APPEAL SUMMARY

Appeal ID: 23380	Project Address: 8230 SE Yamhill St
Hearing Date: 1/29/20	Appellant Name: Ginger Hebert
Case No.: B-001	Appellant Phone: 503-267-3189
Appeal Type: Building	Plans Examiner/Inspector: Peter Drake
Project Type: commercial	Stories: 3 Occupancy: B Construction Type: V-N
Building/Business Name:	Fire Sprinklers: No
Appeal Involves: Alteration of an existing structure LUR or Permit Application No.: 18-273800-CO	
Plan Submitted Option: pdf [File 1] [File 2]	Proposed use: Office -

BUILDING CODE APPEAL - REVISION REQUEST
BUILDING PERMIT #18-273800

WELLNESS CLINIC / HEBERT REMODEL

A PROPOSED REVISION REQUEST STAIRS @ LOWER FLOOR
1/4" = 1'-0"

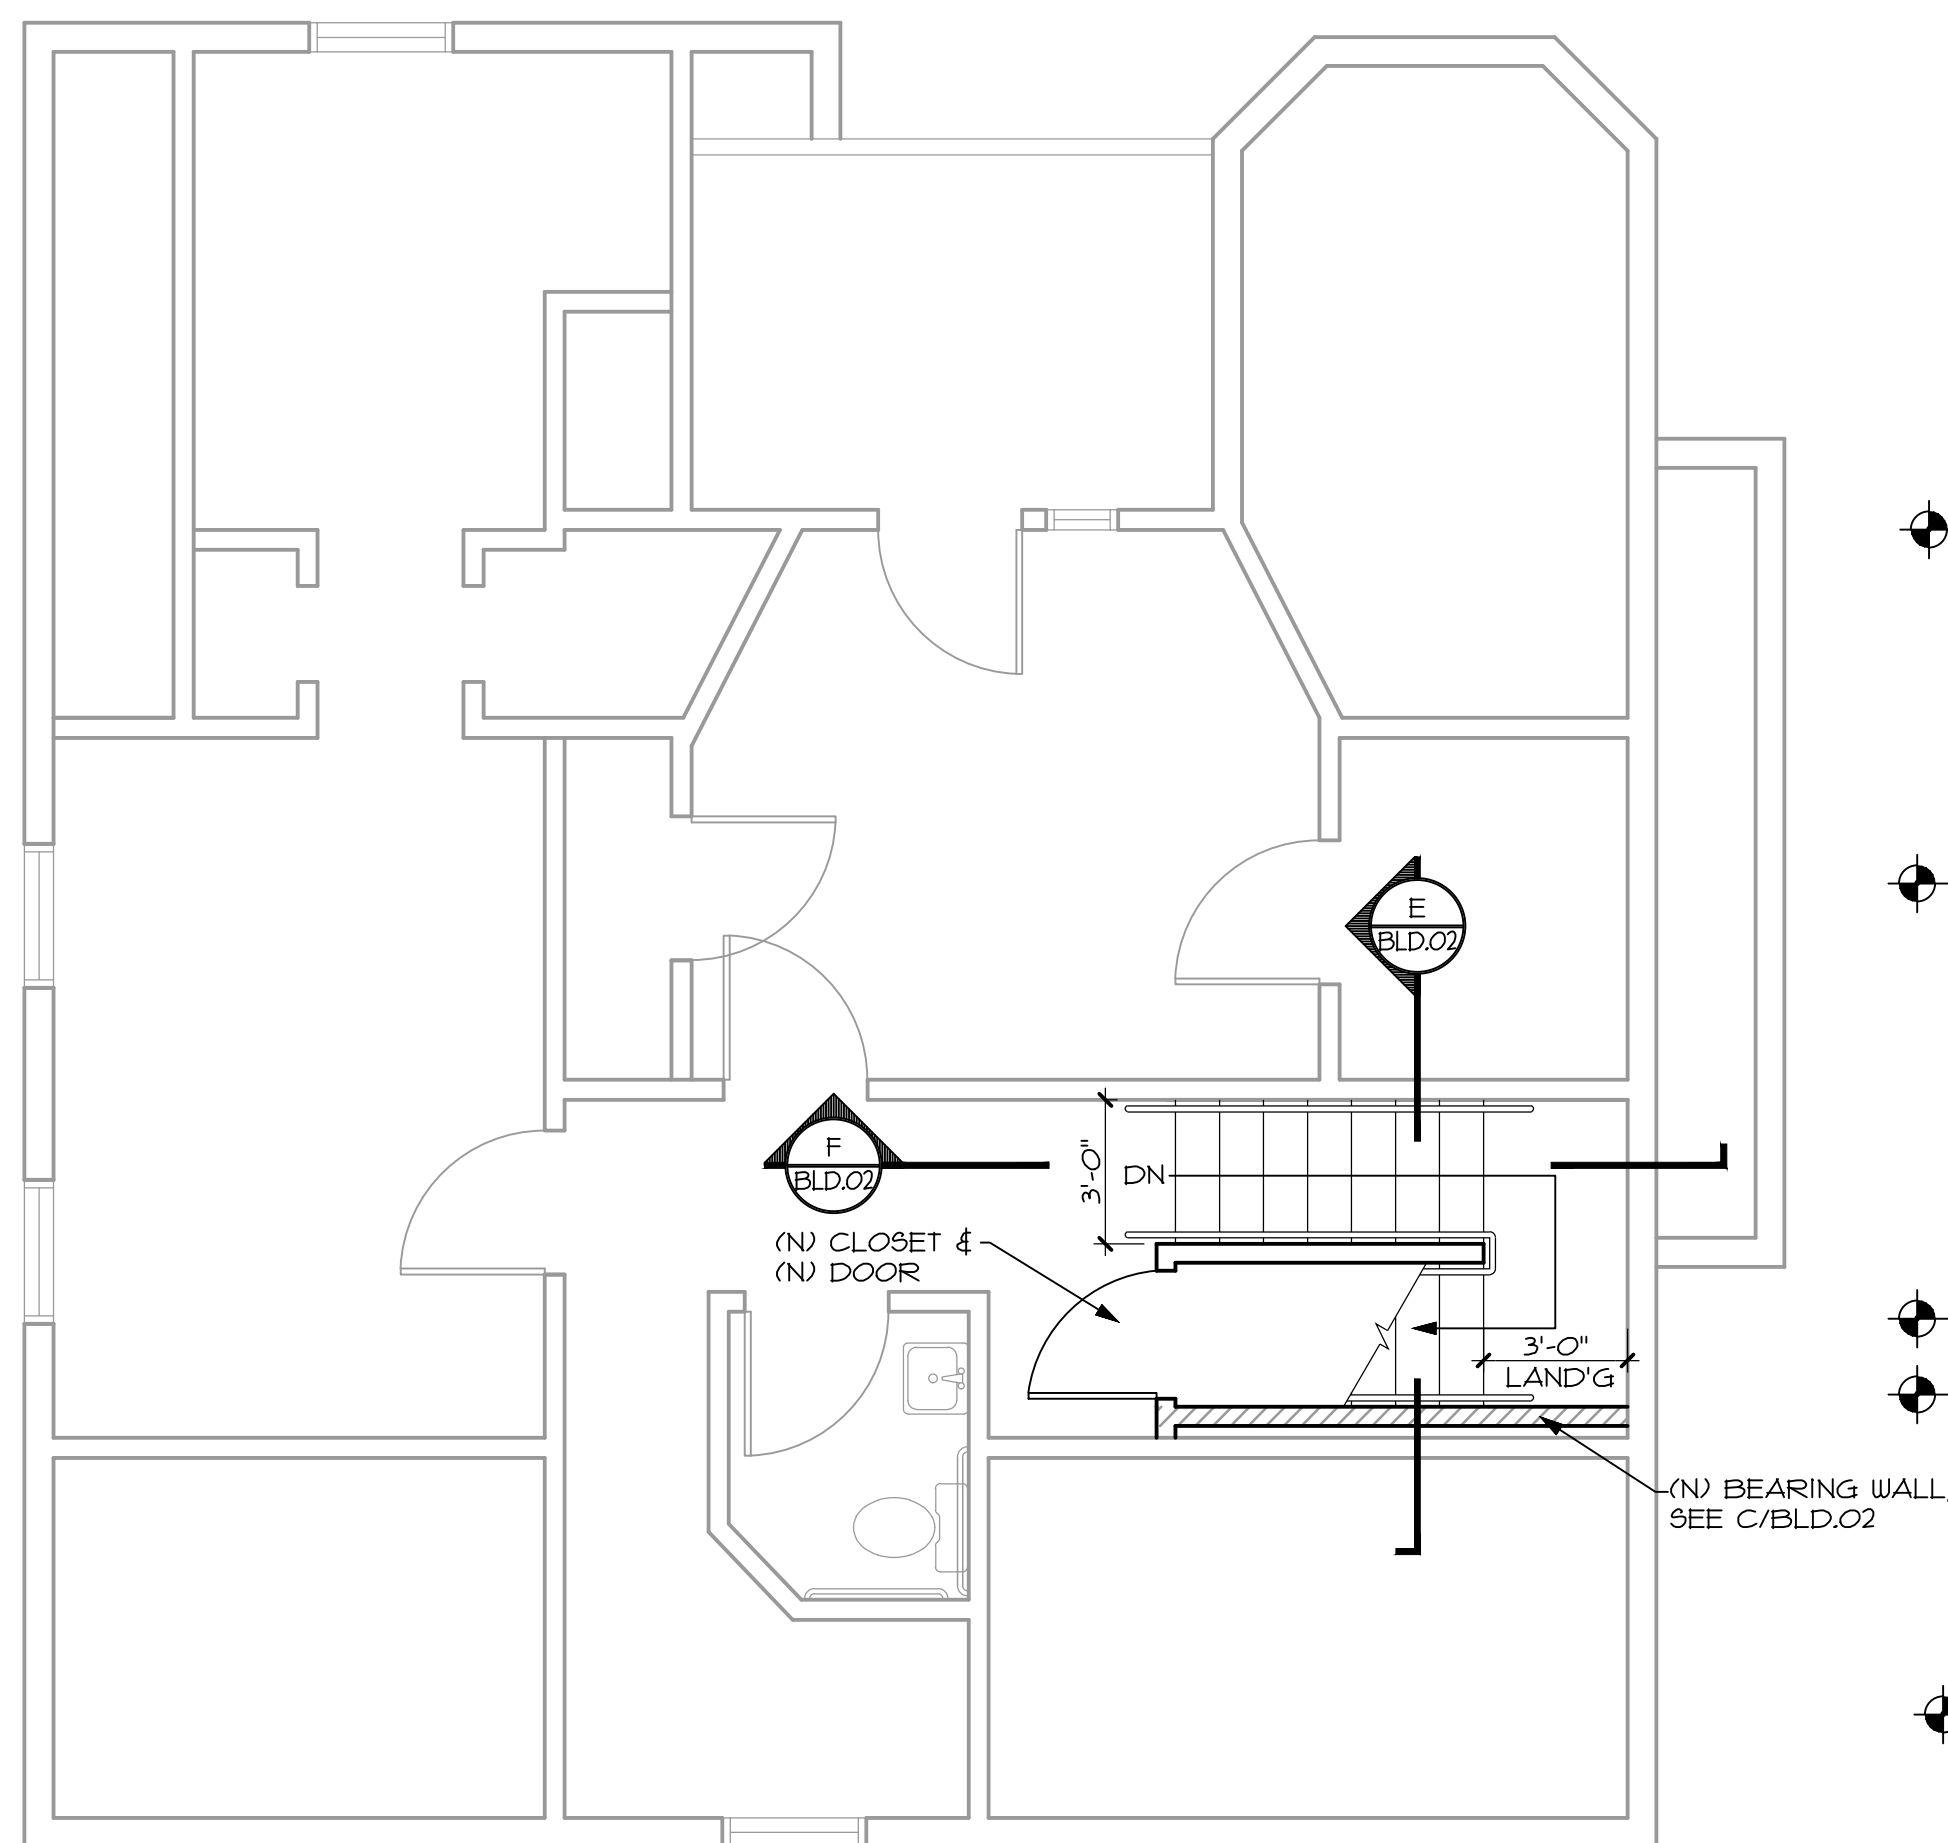
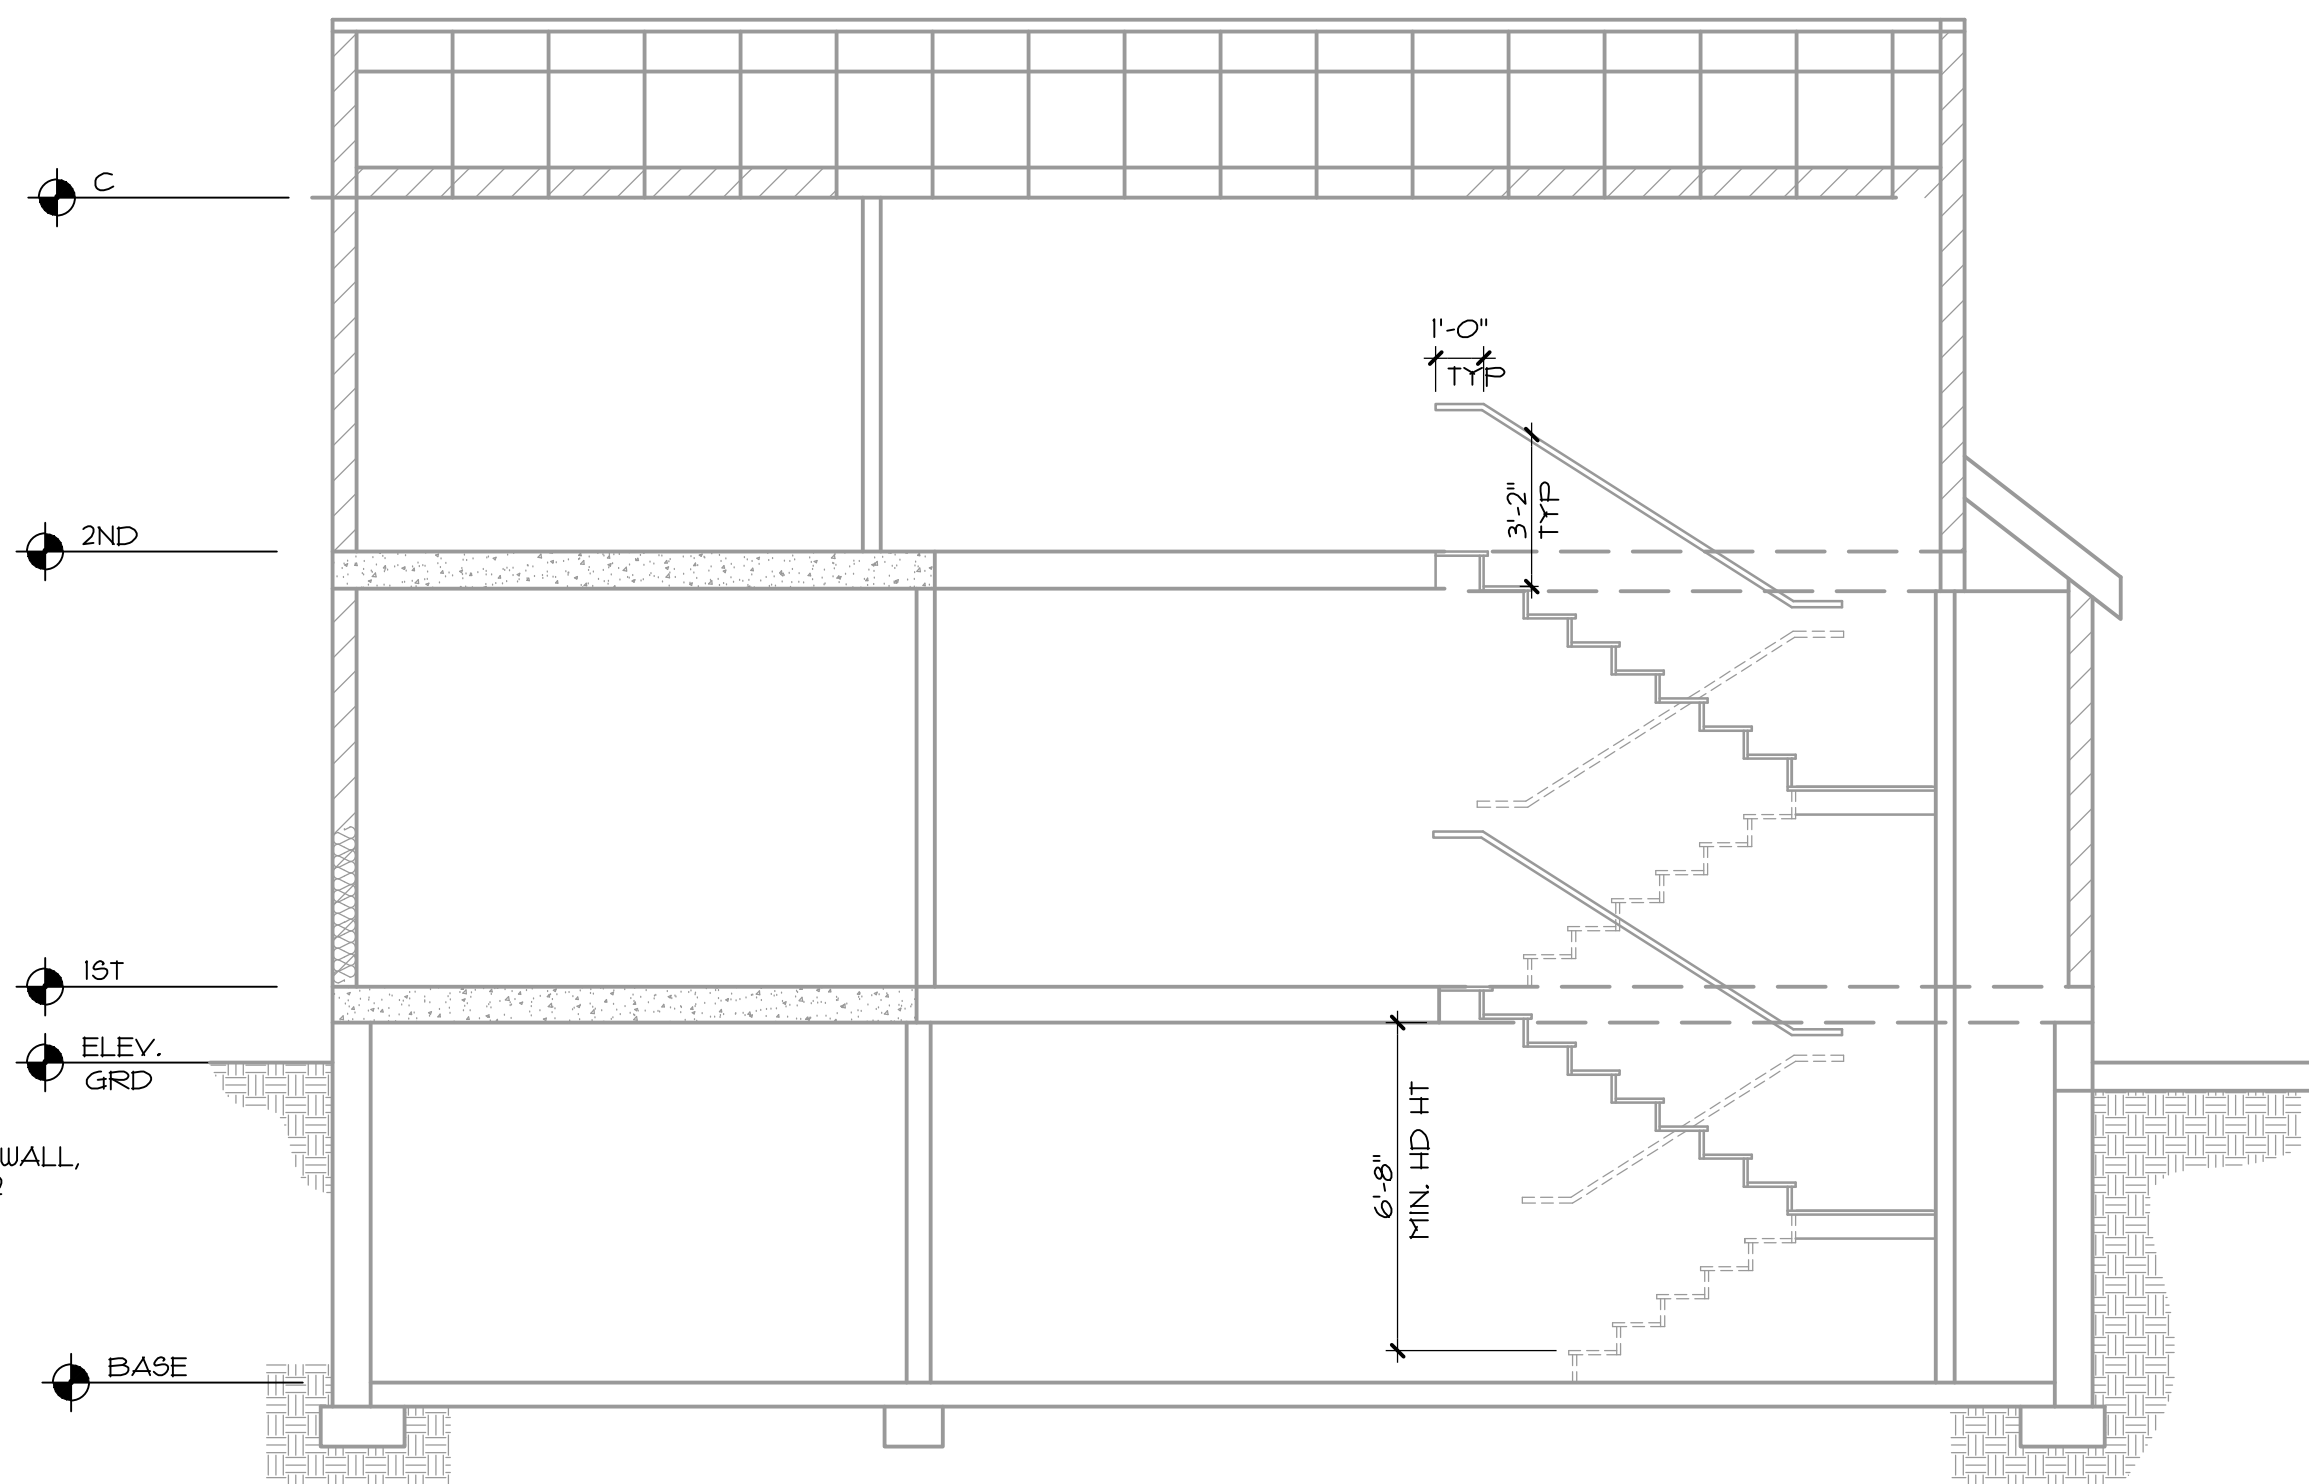
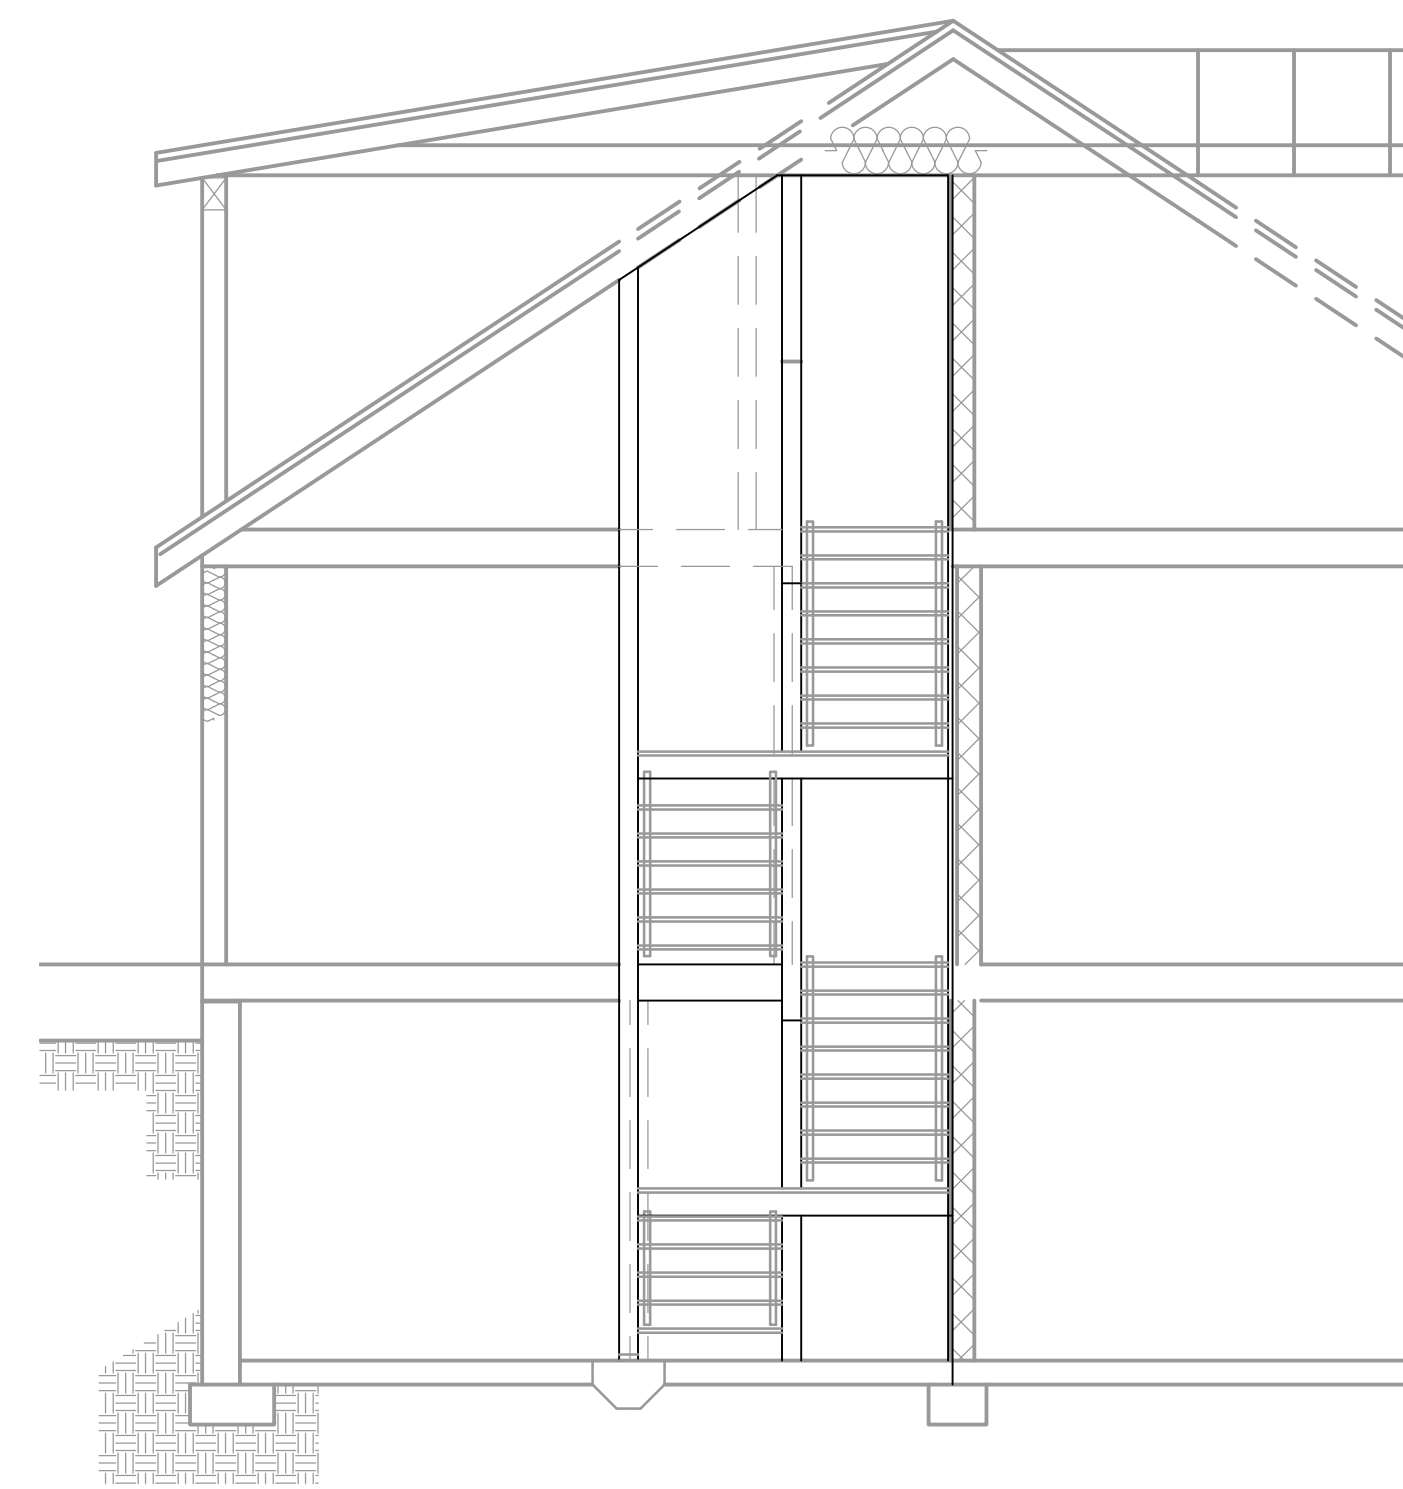
Code Section	2019 Oregon Structural Specialty Code, Chapter 10
Requires	Chapter 10 - Mean of Egress Section 1019- Exit Access Stairways 1019.3..exit access stairways...shall be enclosed with a shaft enclosure..
Code Modification or Alternate Requested	The proposed non-compliant revised stair configuration will substantially improve life safety and overall exiting conditions over the original, initially approved, now demolished, residential "winder" stair design as part of the Change of Occupancy approvals.
Proposed Design	The Appellant proposes anew 36" wide wood frame stair with 180deg. half landing turn. The stair rise and run, handrail locations, and head clearances all meet 2019 OSSC requirements; with the exception of the Code Appeal Section 1019.3. regarding the enclosed shaft requirement. (See Sheet BLD.03) The revision proposes the elimination of the side door (which would require 1-hr rating) for the basement exit, but rather connects the basement directly to the main floor improves the path of travel from the basement to public way. The revision also eliminates the "winder" stair to the second floor, the main floor provides two exits as previous described. (See Sheet BLD.02) This new stair will not only improve life safety but also the functional flow, circulation, security and safety of the clinic.

Reason for alternative	Previous contractor removed the original residential stair(s). These stairs had been permitted as a non conforming, existing condition, but have been removed and no longer exist. If reconstructed as originally designed, the stairs would be too steep, too narrow, with inadequate landings, and insufficient clearances. This original stair configuration consisted of a single flight from basement to an exterior side door, and stacked above, a "winder" stair from main floor to 2nd. The stairs are not contiguous, but are stacked, reliant and dependent on combined layout for vertical clearances

and landings. The basement stair leads upstairs to a narrow 30" landing, (located approx. 24" below main floor), to then exit through a side door directly into a 36" sideyard. The second-floor stair discharges to the main floor with two exits; one to the front street yard and the second to the rear yard. (See Sheet BLD.01)

Reconstruction of existing stairs to connect 3 stories with omission of rated shaft enclosure: Denied.
Proposal does not provide equivalent Life Safety protection.
Appellant may contact John Butler (503 823-7339) with questions.
